Wilson - LH ELEVATION 'D'

Lot 21 Duncan's Creek
295 Beacon Hill Road
Lillington, NC 27546

ARCHITECTURAL DRAWINGS

SECOND FLOOR ELEVATION 'D'

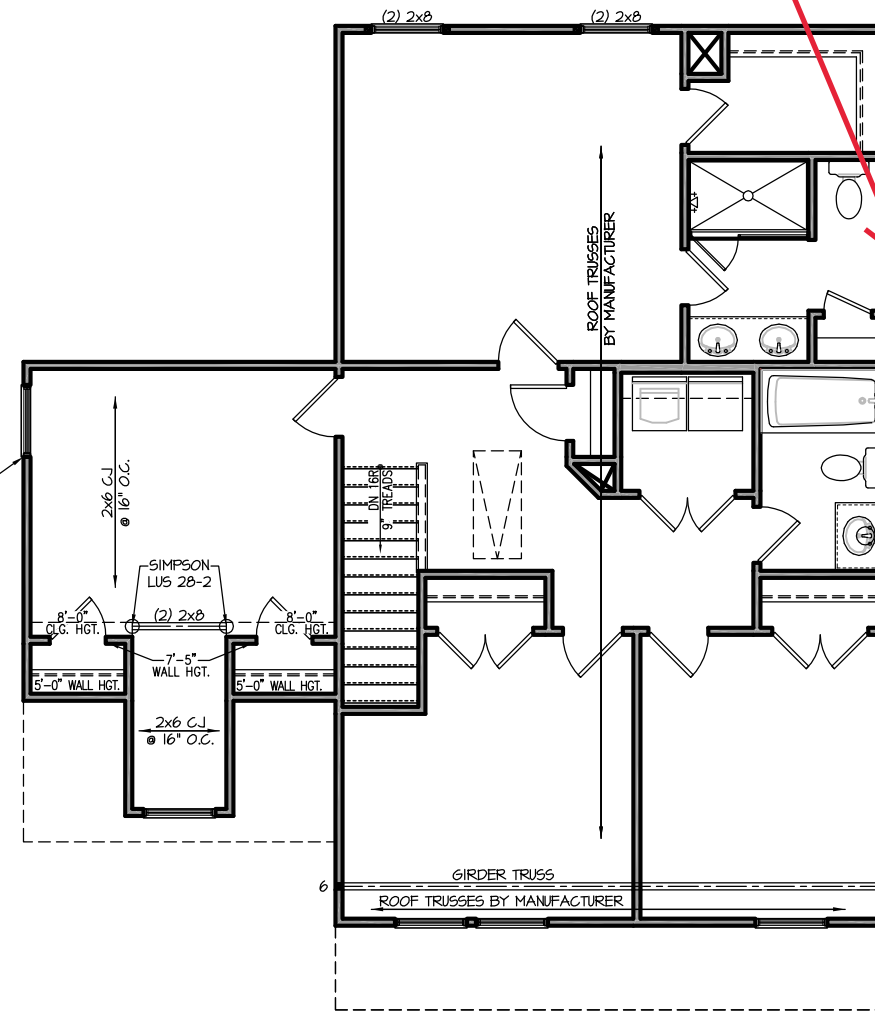
add 2/0 x 3/0 window
see Page 2.2d
